Commentary / objection to proposal 2014/5476/P and 2014/5486/P

The site, 152 Royal College Street, is located within Camden Broadway Conservation Area. The map below shows the boundaries of the conservation area, and highlights the adjacent building (no 154) as a 'positive building'.

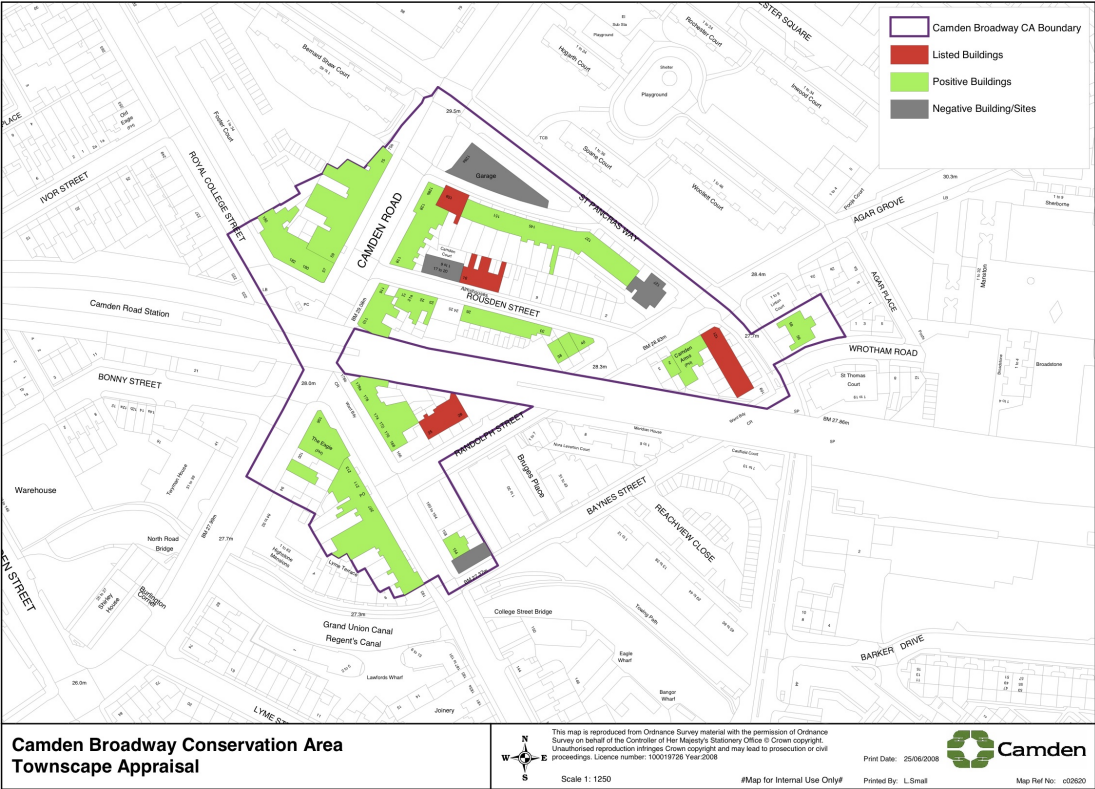
The adjacent building on Royal College Street (no 154) has been designated under "BUILDINGS WHICH MAKE A POSITIVE CONTRIBUTION" and "HISTORIC SHOPFRONTS".
